February 27, 2009

Section 10(j) Preliminary Determination of Inconsistency and Comments on the Draft Environmental Assessment for the DeSabra-Centerville Hydroelectric Project, Federal Energy Regulatory Commission No. 803-087, in Butte County, California.

Figure 1. From page 22 of *DeSabra-Centerville Project, FERC No. 803 ©2007, Pacific Gas and Electric Company Supplemental Fish Population Characterization at Project Diversions March 1, 2007.*

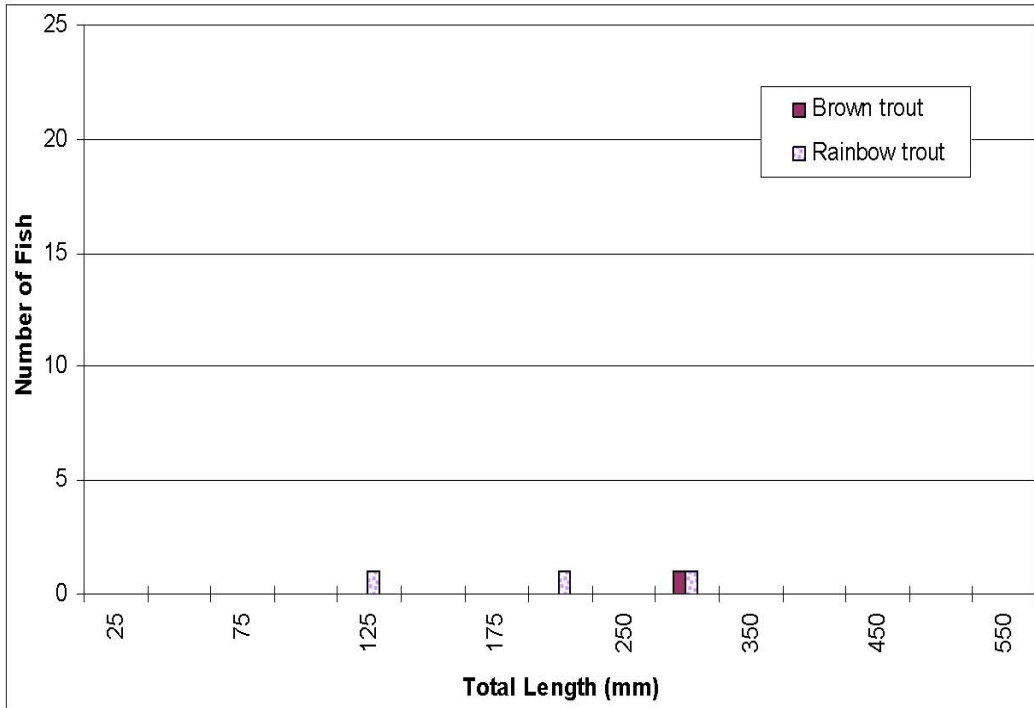
The only discussion of age class structure Department staff can find in the draft EA refers to fish rescued from the canals, not age structure of fish captured or observed in the project affected stream reaches: “*The length-frequency distribution for rainbow trout in Butte canal indicates that all age classes were present (Figure 3-20)*” and in the discussion of Hendricks Canal: “*the length-frequency distribution for both rainbow and brown trout indicates that all age classes were present (Figures 3-21 and 3-22).*”

Using WBFR as an example, there is simply too little data available for FERC staff to conclude that the data “*generally demonstrate that age class structure of the trout populations within project affected stream reaches is sufficient to demonstrate viable fish populations.*” The three figures below, from the licensee’s documents, graphically depict three areas of the WBFR; the reach above the diversion, the canal that diverts 80-100% of the water, and the reach below the diversion. Of the three graphs presented by the Licensee, the third graph shows the distribution most typical of a healthy, viable population. Unfortunately, all those fish are in the canal, not the project affected stream reach. The other two graphs speak for themselves.

Figure 5. Trout abundance estimates calculated from linear abundance reported in FLA.

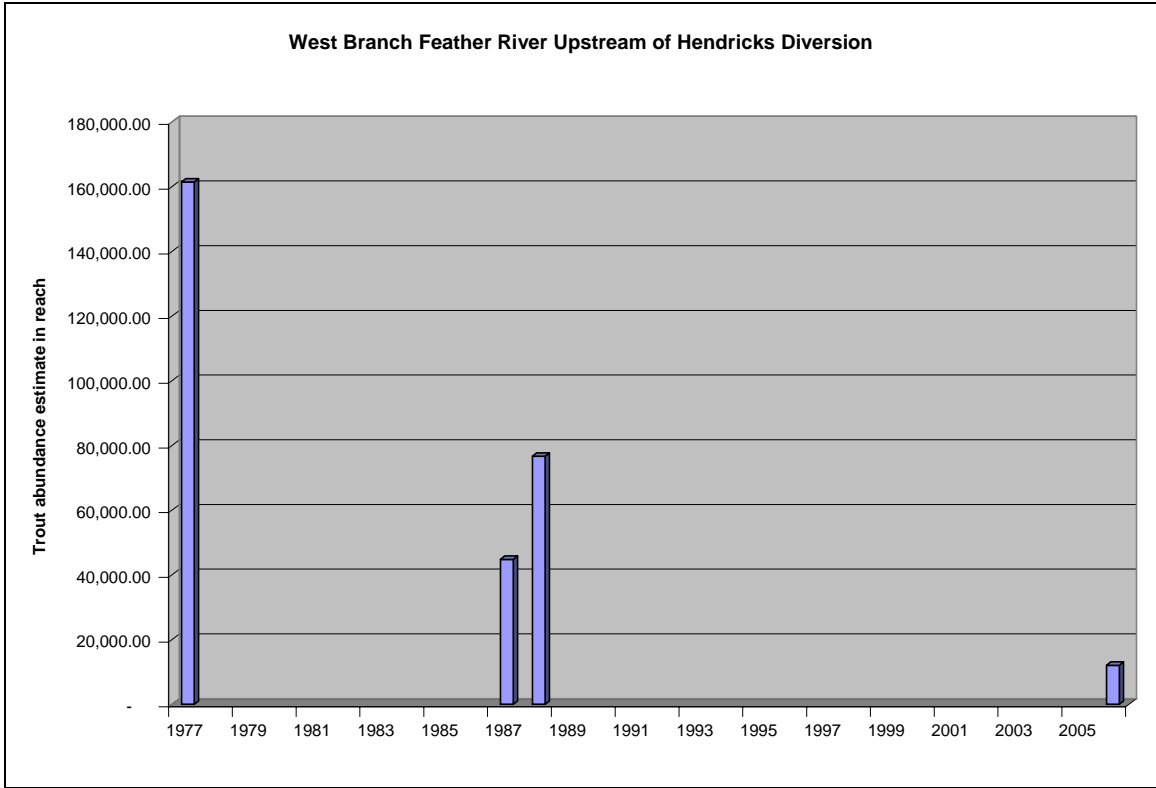
In the 13.2 mile reach upstream of Hendricks Diversion, mean linear abundance has gone from 760 trout per 100 meters in 1977, to 57 trout per 100 meters in 2006; roughly a 92% reduction in 29 years. This decline in current abundance when compared to historical abundance would indicate that the populations are not “viable and generally healthy”.

In the 14.1 mile reach downstream of Hendricks Diversion, linear abundance has dropped from 723 trout per 100 meters to 51 trout per 100 meters, about 7% of what was documented in 1977. By any reasonable person’s definition, a 92% reduction is a significant cumulative impact. This decline in current abundance when compared to historical abundance would indicate that the populations are not “viable and generally healthy”.

When comparing trout *abundance* to historical observations, there is a distinct downward trend seen in trout numbers over the last 20 to 30 years (Figure 5 and 6).

Figure 6. Trout abundance estimates calculated from linear abundance reported in FLA.

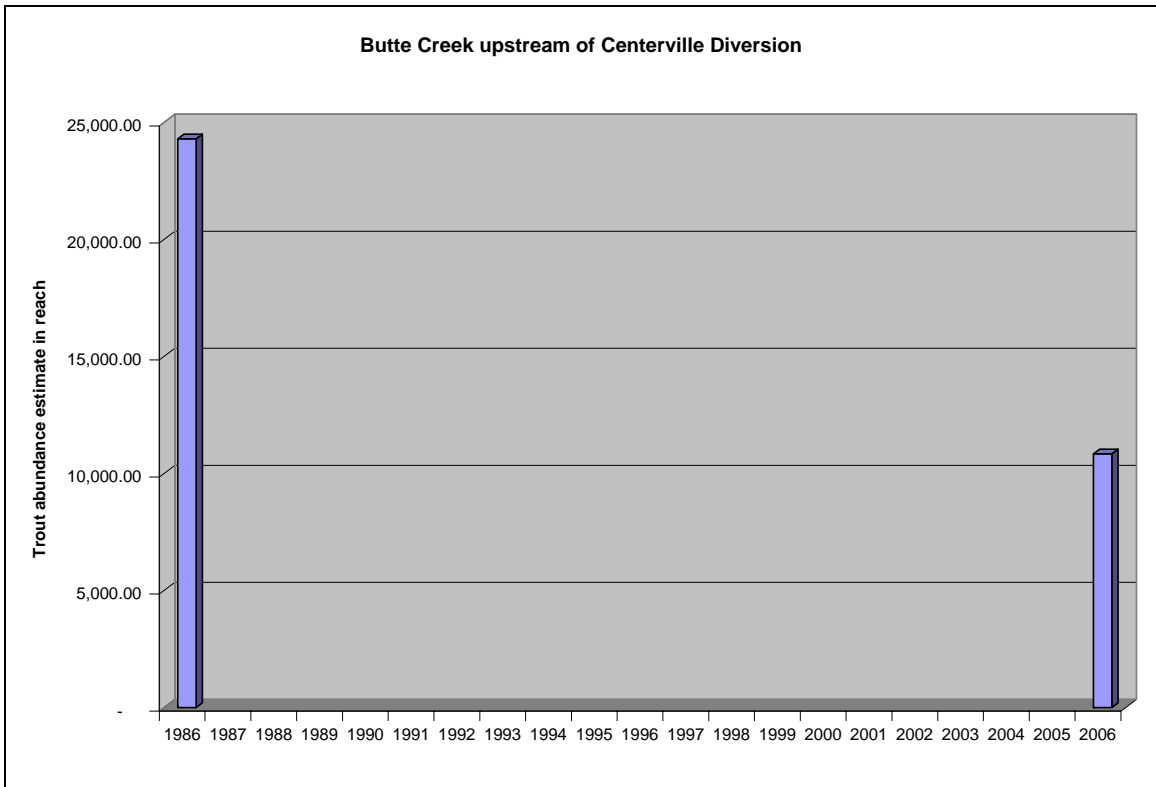
On Butte creek, in the 10.2 mile reach below the Butte Head Diversion and above the Lower Centerville Diversion, mean linear abundance was 148 trout per 100 meters in 1986 and 66 trout per 100 meters in 2006. There has been a 55% reduction in abundance over 20 years. This decline in current abundance when compared to historical abundance would indicate that the populations are not “viable and generally healthy”.

Figure 7. From page 10 of DeSabra-Centerville Project, FERC No. 803 ©2007, Pacific Gas and Electric Company Supplemental Fish Population Characterization at Project Diversions March 1, 2007.

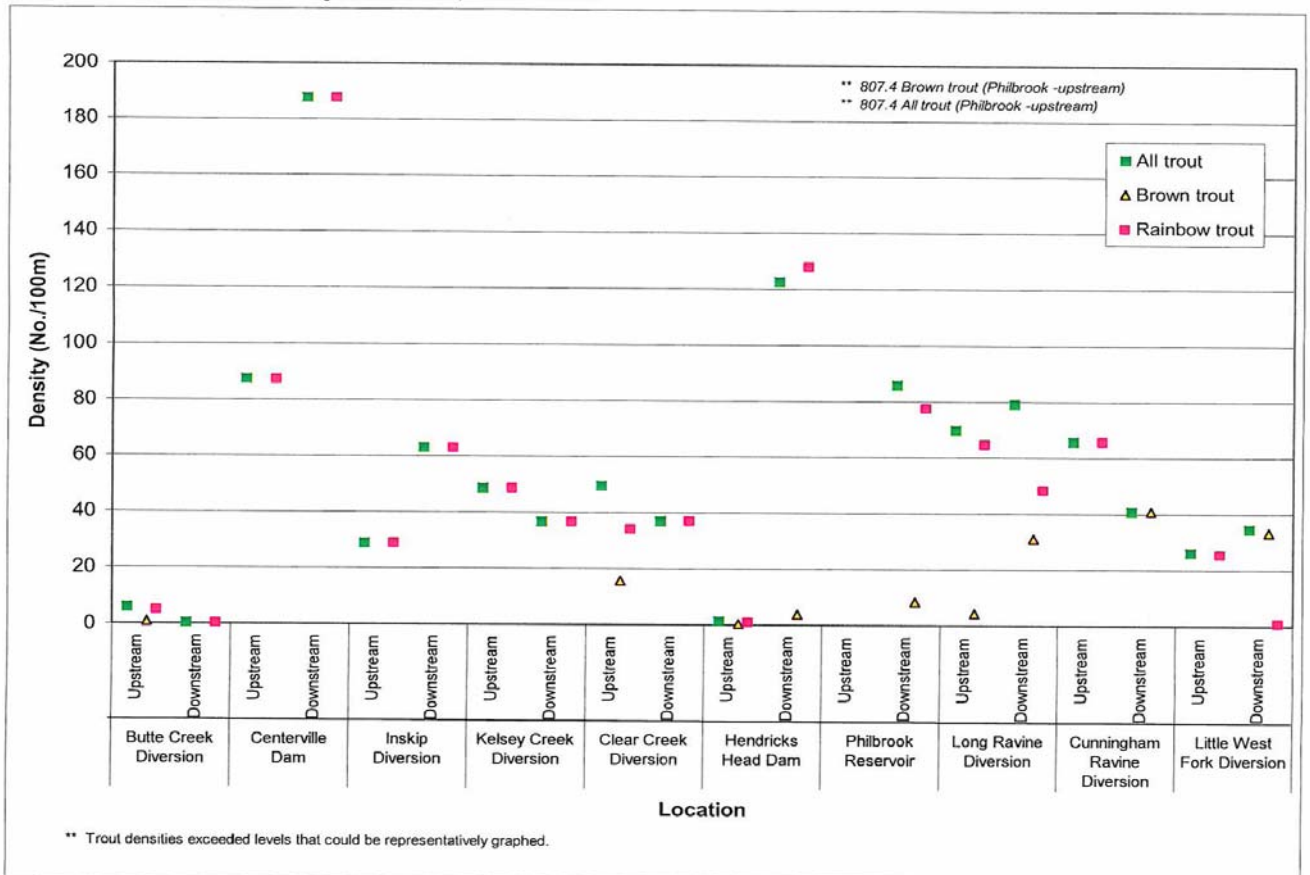
The Department agrees with the Applicant’s concern that *“The tie between population estimates and fish potentially entrained in Project facilities can not be definitively described by the existing population estimates.”* Because of the unexplained variability in the fish sampling data only relative values can be compared during any one year. However, the Licensee also states that *“Trout*

densities upstream of the (Hendricks Head Dam) diversion were low relative to other project reaches" (see figure below from page 10). In fact if you look at the graphic the licensee provides, both Centerville and Hendricks have much lower population densities in the reach above the diversion than in the reach below the diversion.

Figure 8. West Panther Creek entrainment data

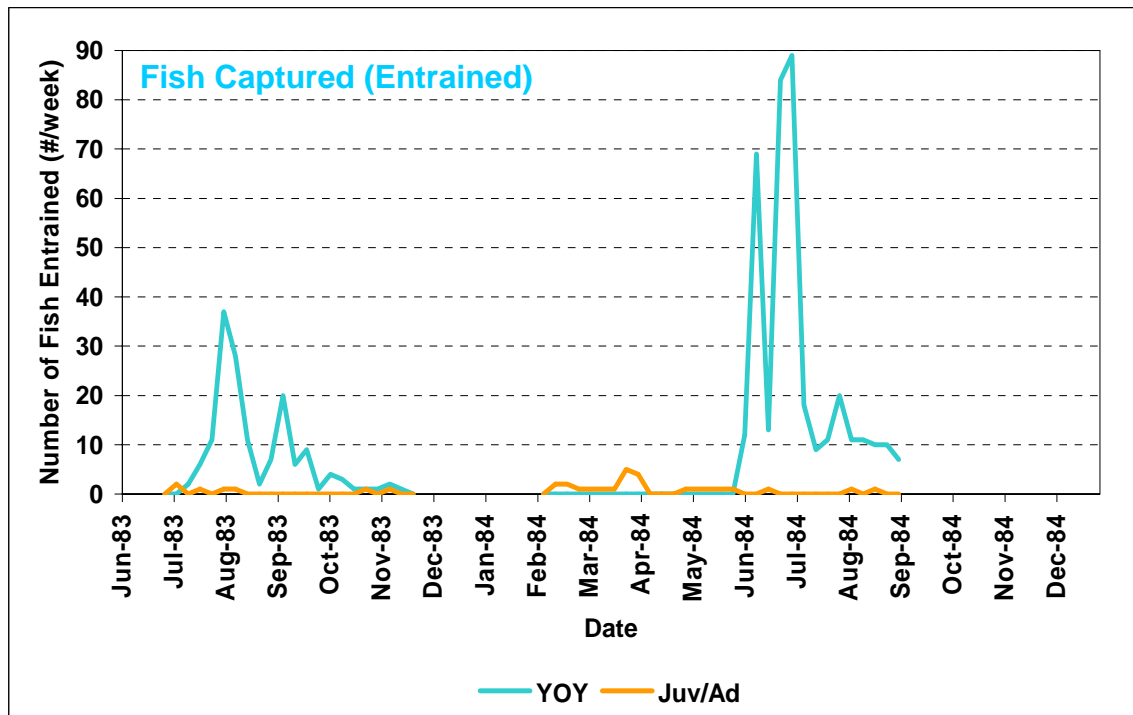
Another important entrainment issue that must be considered in a cumulative impact analysis relates to the periods when trout are most vulnerable to entrainment. For the WBFR, this vulnerable period coincides with the period when the project is no longer spilling and therefore more fish are entrained. Empirical data collected by PG&E from 1983 to 1984 on the Mokelumne River Hydropower Project (FERC Project No. 137) at the West Panther Creek Diversion structure (Figure 8). The graph below shows juvenile/adult fish were captured during late March through early April and young-of-the-year (YOY) fish were captured from late May through mid-October. This corresponds to spawning movement for juvenile/adult fish and downstream migration or passive movement for YOY. Perhaps it also provides an explanation for the lack of YOY

in the reach above the Hendricks diversion and the higher number of YOY found in the canal.

Figure 9. West Panther Creek streamflow data.

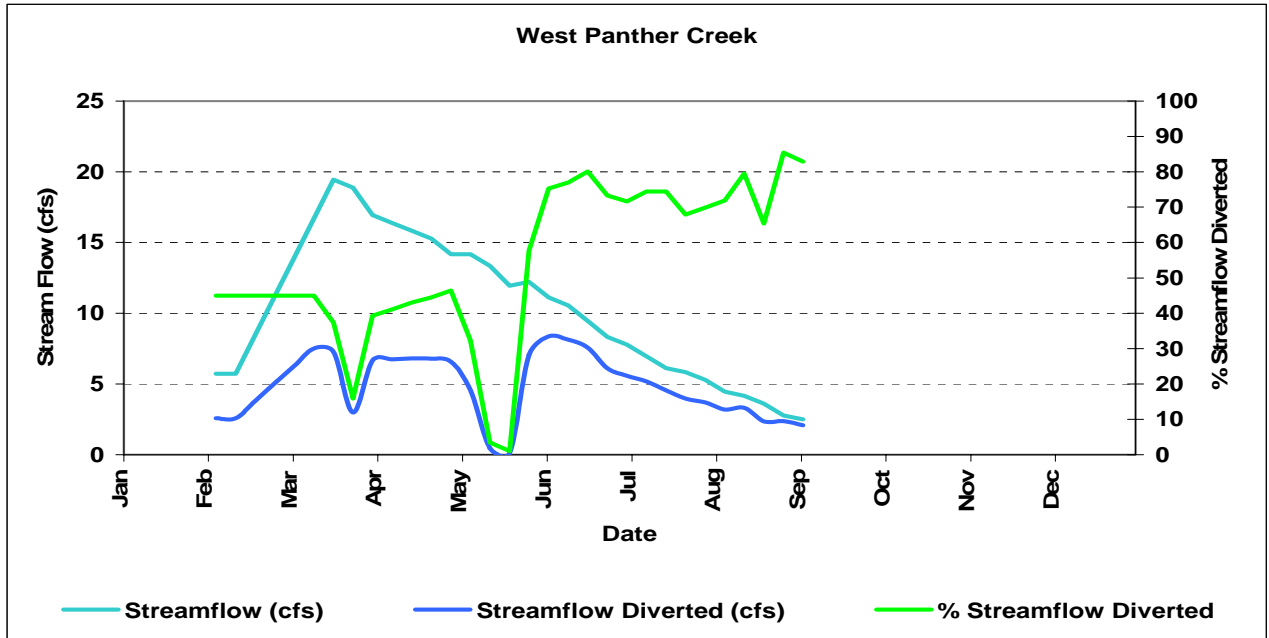
Another factor to be considered in a cumulative impact analysis is the positive correlation that exists between the amount of streamflow, the percentage of streamflow diverted, and the number of YOY captured (Figures 8 and 9). On the WBFR, approximately 80% of the water is removed from the watershed via an inter-basin water transfer; all but the approximately 20% bypassed flow is lost from the WBFR ecosystem. Again, perhaps this helps explain the lack of YOY in the stream reach above the Hendricks diversion, and the high number of YOY in the Hendricks canal.

Figure 10. Rainbow Trout movement in the Truckee River

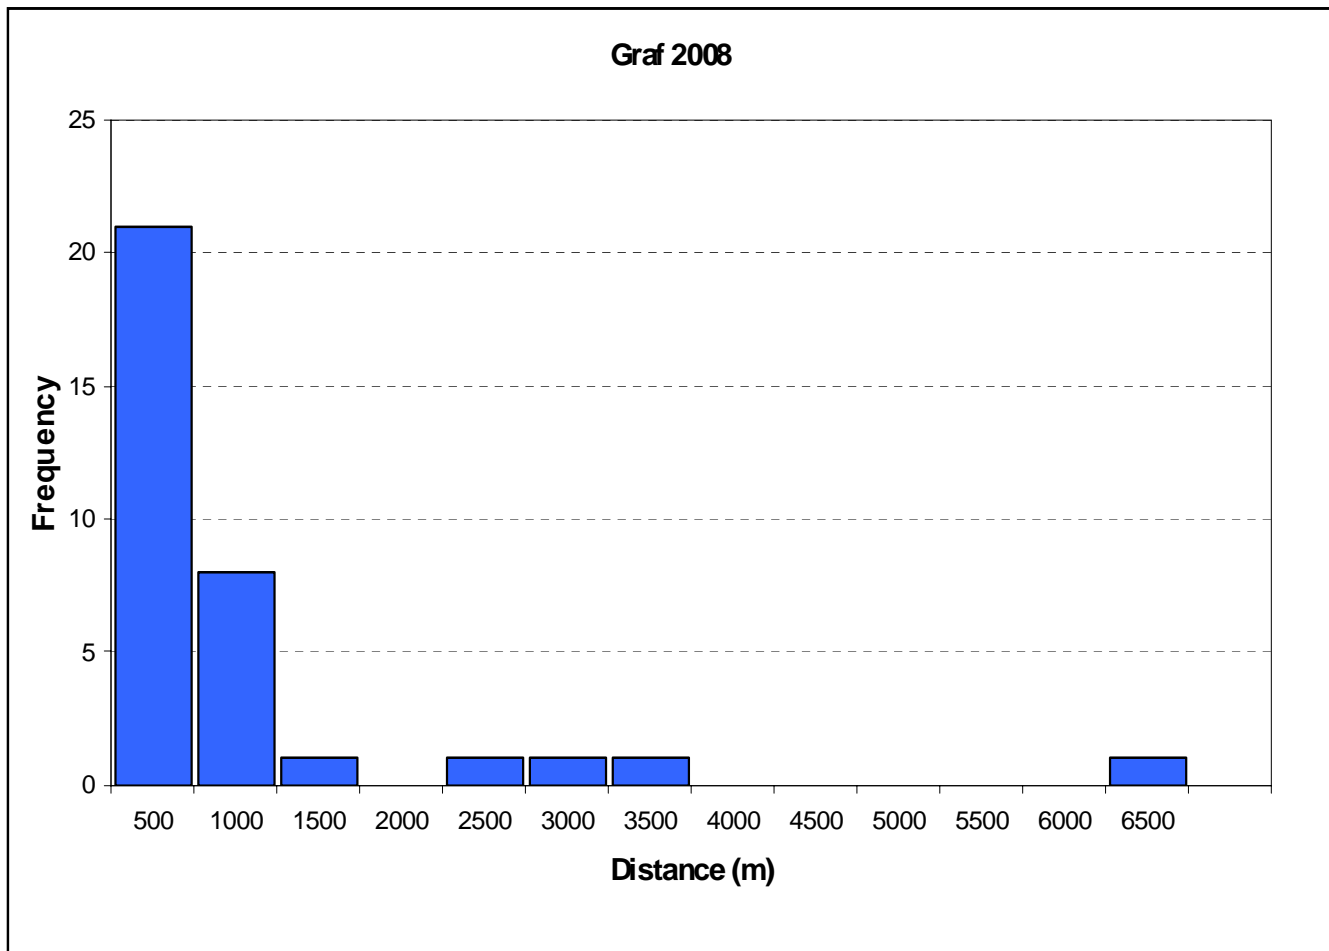
While it is true that *“resident trout populations do not rely on spawning migrations to fulfill their life histories”*, studies have shown that both juvenile and adult trout move considerable distances as a normal part of their behavior. Graf (2008) shows that rainbow trout may move as far as up to 6500 meters (4.1 miles) (see Figure 10) in the Truckee River, a northern California Sierra

stream. This study tracked 39 rainbow trout which were relocated every 1-2 weeks for 1 year. The fish were tagged for relocation and GPS readings (10-20 meter accuracy) were taken to locate trout positions. The methodology also included staggered tagging so that movement during all 4 seasons was captured. The majority of fish tagged moved between 500 and 1000 meters. However 15% of the fish moved between 1500 and 6500 meters. This indicates that rainbow trout population movement is plastic and genetic flow may take place up to several miles upstream and downstream each season. Therefore, considering multiple years of movement, the WBFR rainbow trout population is capable of genetic flow throughout both the lower WBFR and the upper WBFR sections, and all their tributaries. However, this genetic flow cannot happen because the project blocks movement.

Figure 11. Adult Trout % of Maximum WUA Above and Below Hendricks Head Dam Diversion on WBFR.

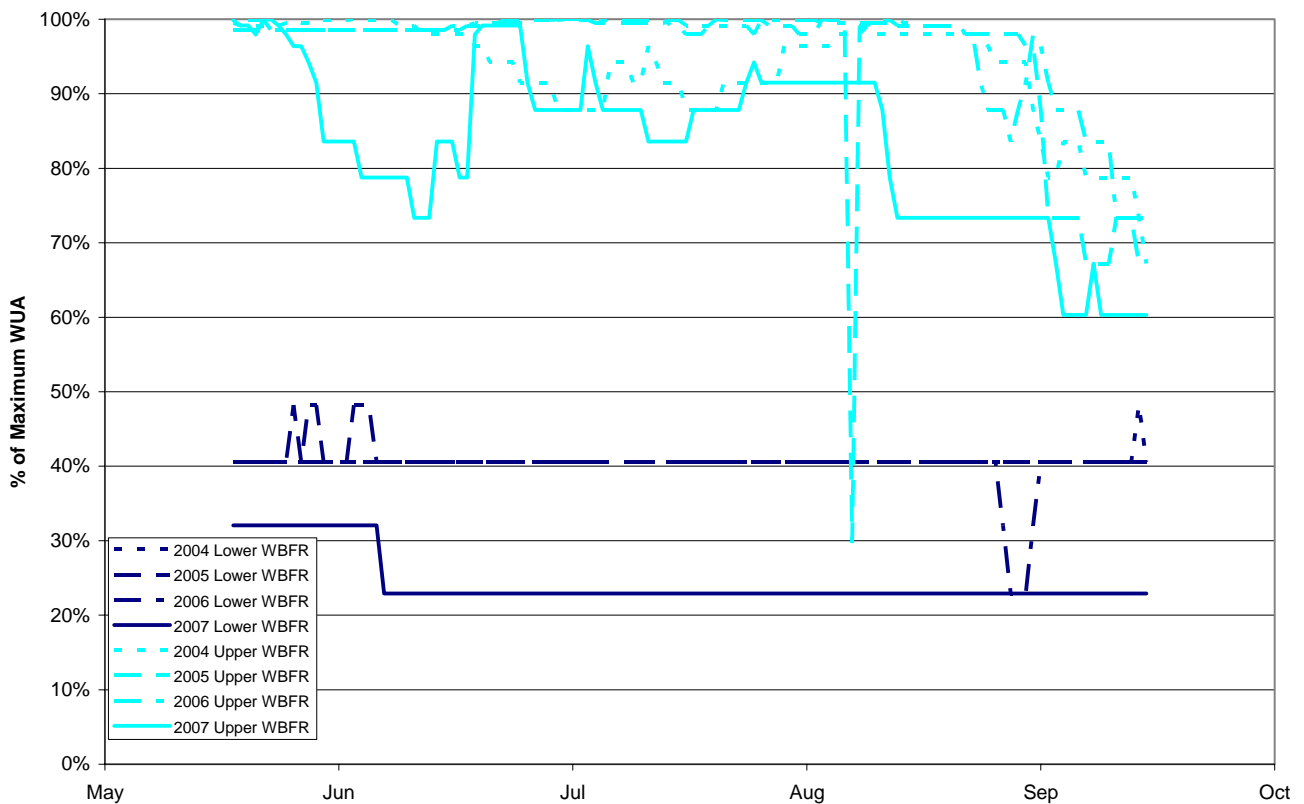
The Department also looked at adult fish habitat above and below the Hendricks Diversion Dam to compare the relative abundance of available adult fish habitat for the years 2004 through 2007 based upon recorded hydrology

(Figure 11). The analysis shows that there is between 60% to 100% of the maximum WUA available habitat for growth and rearing of adults **above** the Hendricks Diversion Dam. Below Hendricks Diversion Dam, the available adult habitat values range from 23% to 48%. The majority of available habitat is upstream of the dam in both normal and dry years. The Department believes that allowing fish in the lower river access to upstream areas will allow for better protection of the fisheries resource and help mitigate for low releases below Hendricks Diversion Dam during both wet and dry years. Moreover, this general comparison to habitat available above and below the dewatering of the WBFR at Hendricks Diversion Dam, only accounts for the habitat in the WBFR itself. It does not consider the additional habitat that could be accessed in the tributaries, providing cumulative benefits to population genetics through the broader exchange and expansion of genetic material. FERC staff needs to analyze the cumulative impact that this habitat disconnection has had on the viability and health of the population.
